CITY OF ALBUQUERQUE

RE: **Campbell Compound**
Drainage Report and Grading Plan
Engineer's Stamp Date 7/21/17
Hydrology File: G13D032

**CAMBELL
SUBDIVISION**
LAS VENTANAS NM, INC.

GRADING & DRAINAGE PLAN

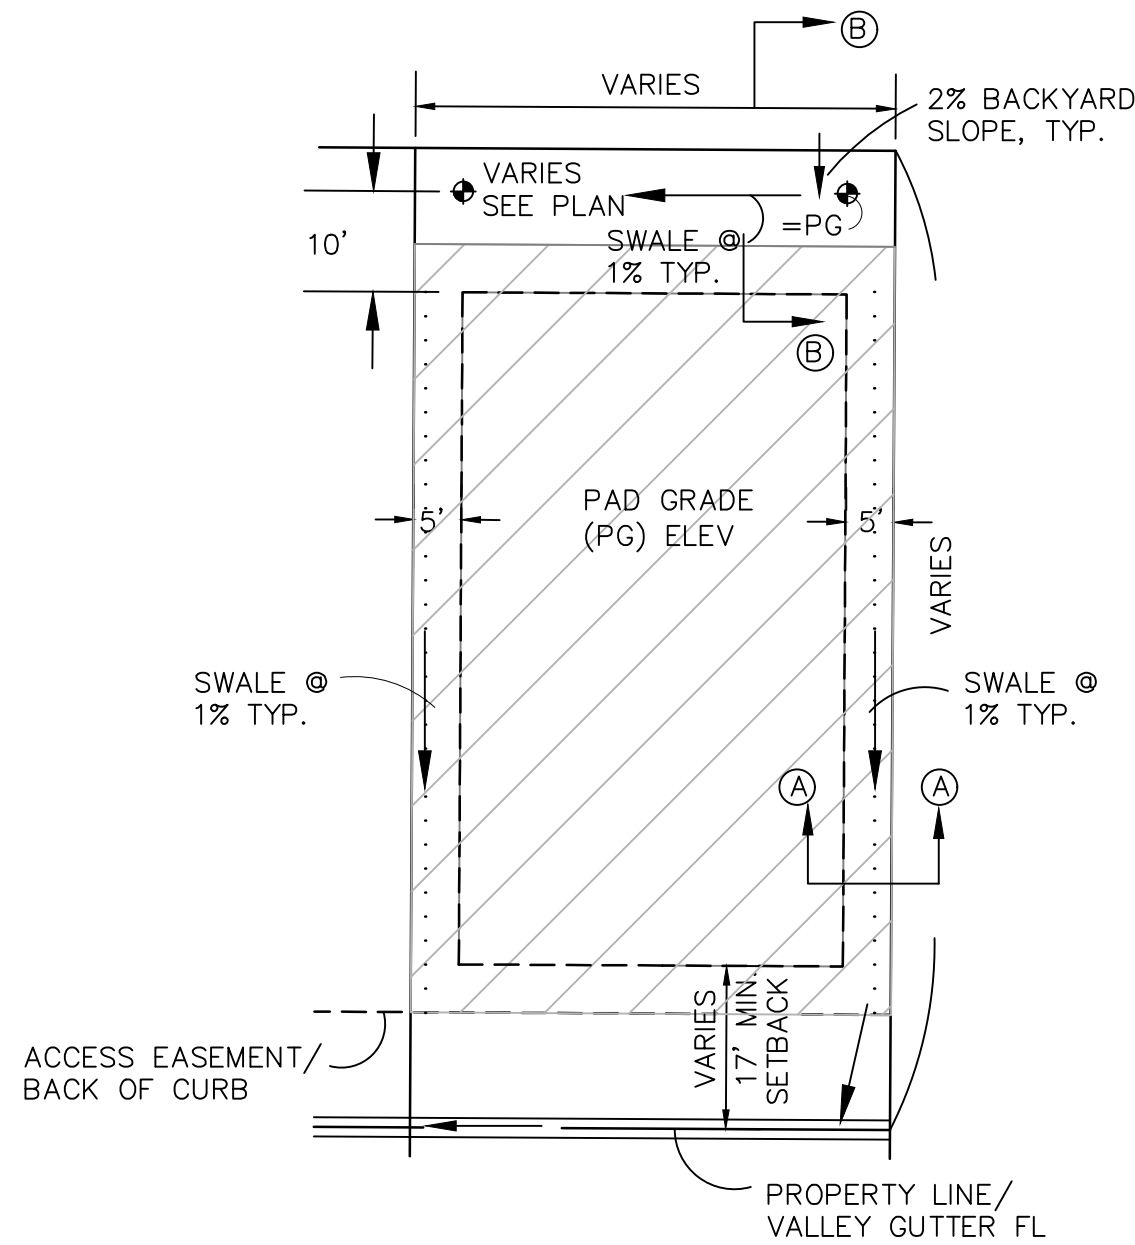
1. It appears that the Maximum Water Surface Elevation (MWSE) in the commons area pond will be higher than the adjacent Campbell Farm subdivision:
 - 1.1. Extend topography into the Campbell Farm subdivision and include Campbell Farm Lane, Lot 11 topo and finished floor.

- 1.2. Provide a section view through the pond (including the MWSE), property line and onto lot 11 of Campbell Farm subdivision.
 - 1.3. The pond will need to be excavated to contain the MWSE below the adjacent subdivision with freeboard (1ft below the Campbell Farm Lot 11 finished floor).

2. Existing and proposed drainage along Campbell Rd.
 - 2.1. The existing drainage appears to sheet flow off the south half of Campbell into a roadside swale that ponds until eventually infiltrating. The existing farmstead is lower now and does not drain at all into the Campbell Rd ROW.

- 2.2. Provide a ponding area along the cottonwood row capable of maintaining the 10day, 100yr MWSE below the sidewalk and at least 1ft below the finished floors on lot 1 and lot 7.

- 2.3. The proposed drainage from Basin A can be held in the cottonwood row ponding area or be diverted south to the commons area pond. The south half-street of Campbell Rd should be able to sheet flow into the cottonwood row. Attempting to convey flows east on Campbell Rd in curb and gutter would lead to more ponding on the road between the entrance of Campbell Farm Ln and the Griegos Drain.

- 2.4. Provide a proposed road section for Campbell Rd and tract B/C. This should also incorporate the traffic requirements for frontage improvements.
- 2.5. The valley gutter in across the Kayla Lane entrance likely won't convey flows with this scheme and can be removed.

- 2.6. A 10' transition section will be needed to connect to the Campbell Farm frontage that lays down the standard curb and gutter and lowers the sidewalk to suit this project's frontage.

- 6.1. Raising the grade in this subdivision will put it several feet above the Campbell Farms subdivision. Ensure no drainage will exit this project site and impact this adjoining subdivision.
- 6.2. Include a section view though the property line between Campbell Farm Rd and the Campbell Compound east lots.
- 6.3. The backyard walls and footers (Section B-B) will need to be wholly contained on this project's property, unless written concurrence can be provided by the adjoining property owners for common walls.
- 6.4. Show the property line, section cut, and dimensional data for the double retaining wall.
- 6.5. Provide additional dimensions on the wall sections: max height retained, max privacy wall heights, and offsets.

TYPICAL LOT GRADING DETAIL
SCALE: 1"=20'

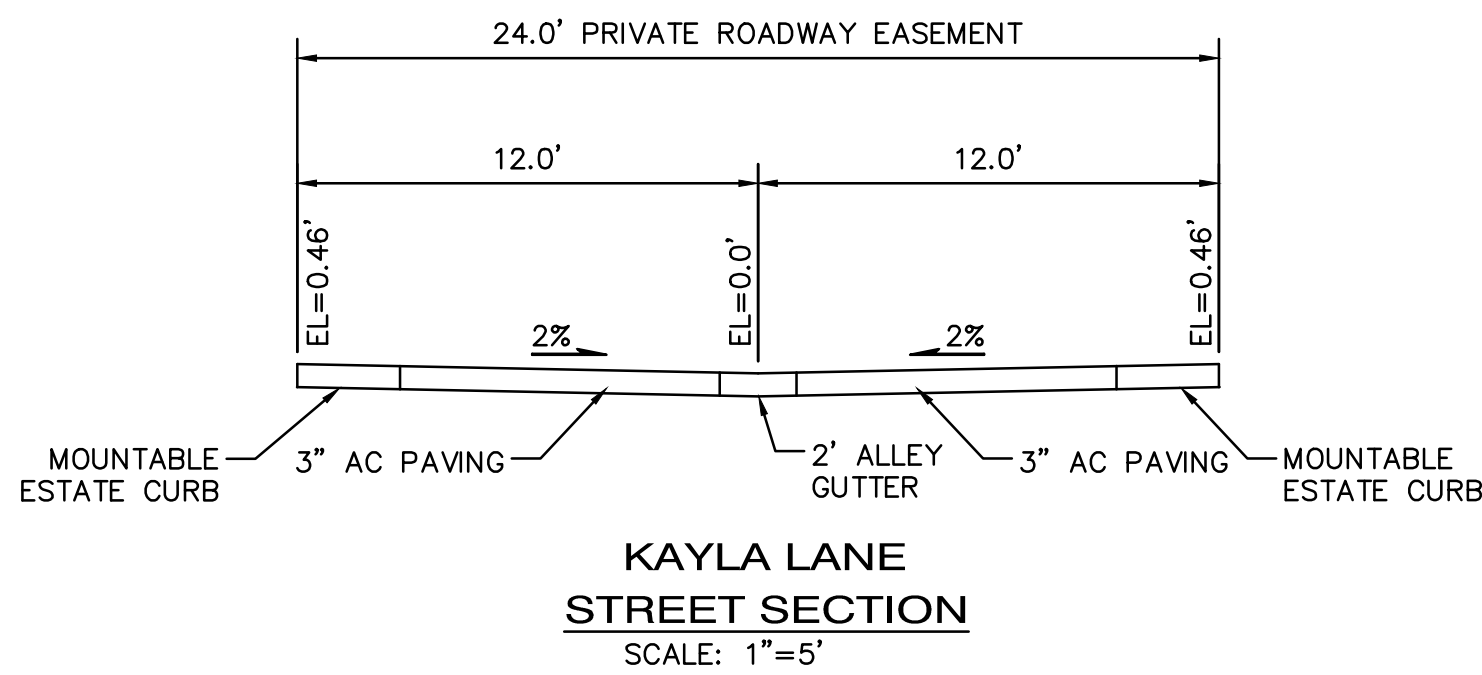
- 6.6. Increase the slope and specify a minimum depth at flowline along the backyard walls; clarify the typical lot grading detail to show the backyard drains to the front (Kayla Ln) and no cross lot drainage or drainage through the backyard wall occurs.
7. Are any easements required for the ditch and will they conflict with the pad or wall locations?

DRAINAGE BASIN EXHIBIT

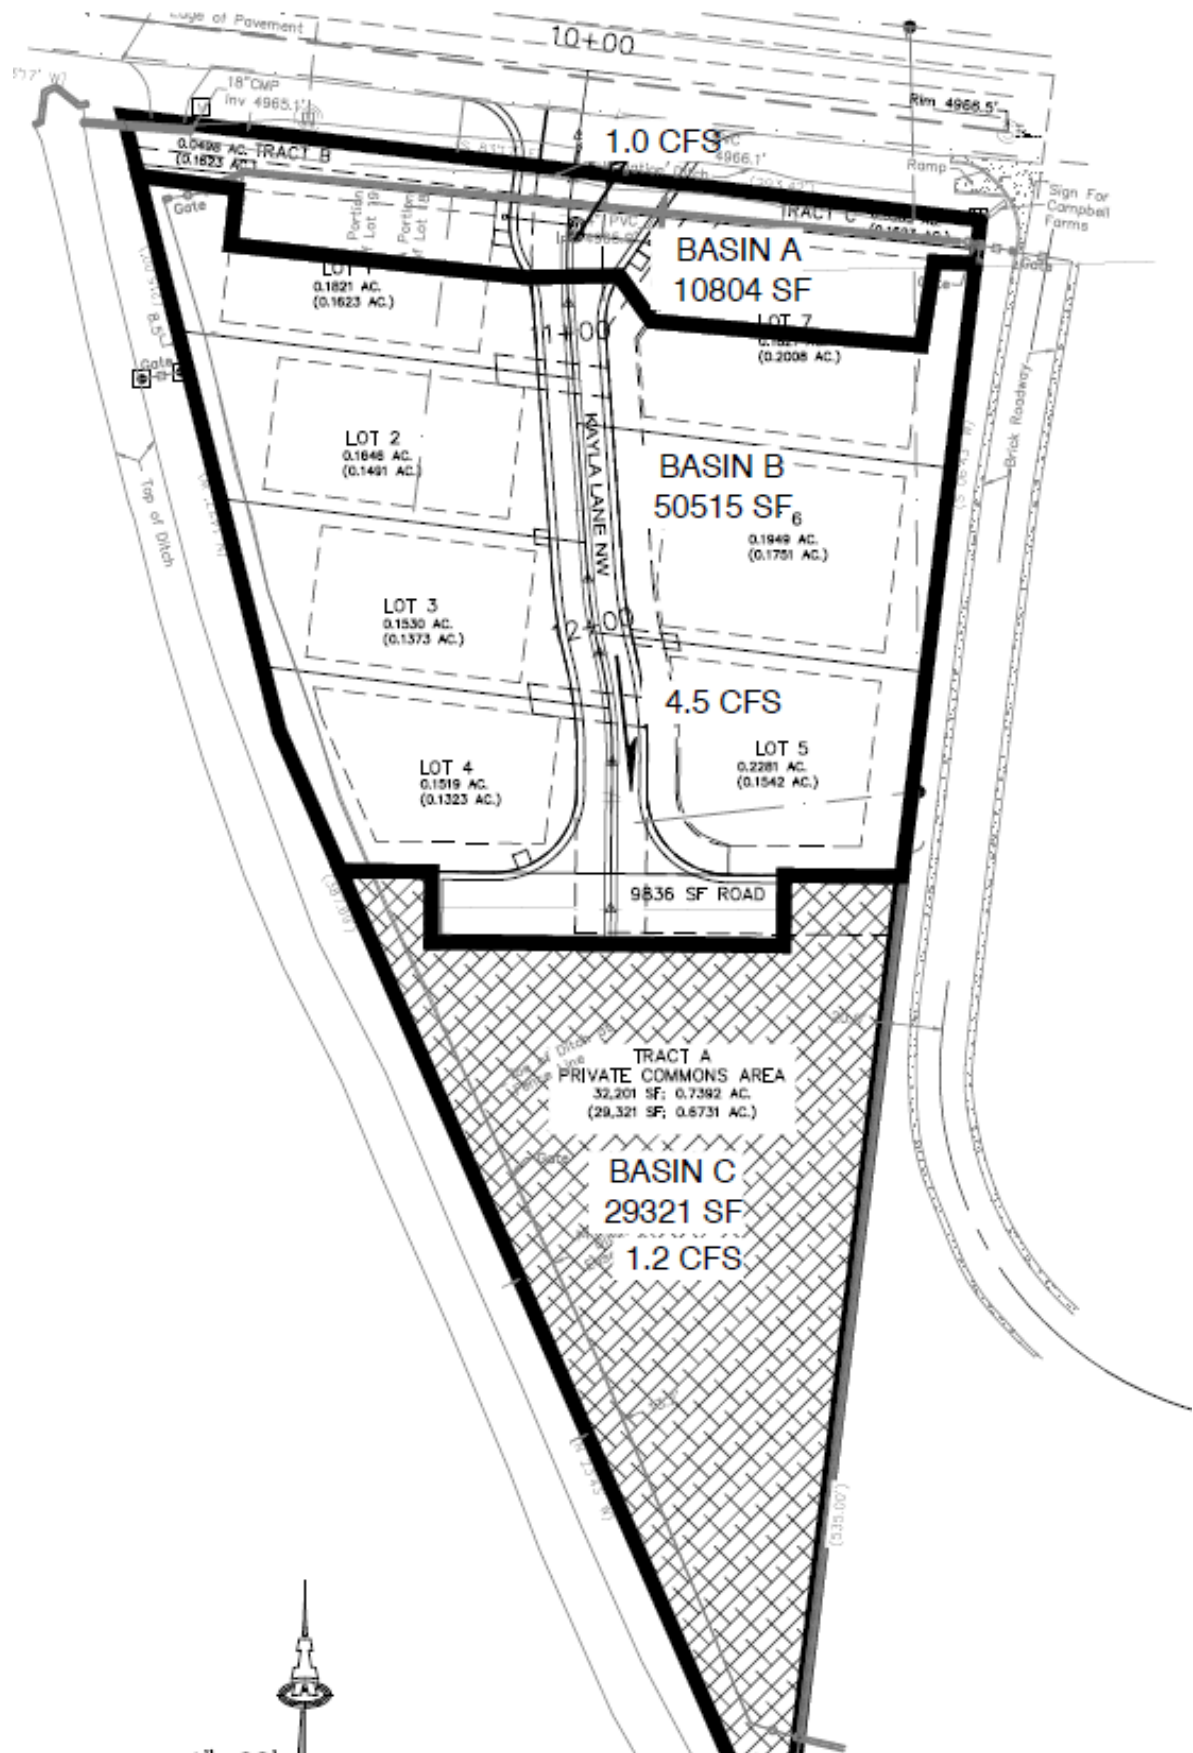
3. Offsite Flows. Runoff and volume calculations need to anticipate flows entering this site from the Conservancy berm and its access road along the east side of the Campbell Community Ditch. It is difficult to tell from the basin map if this area was included.
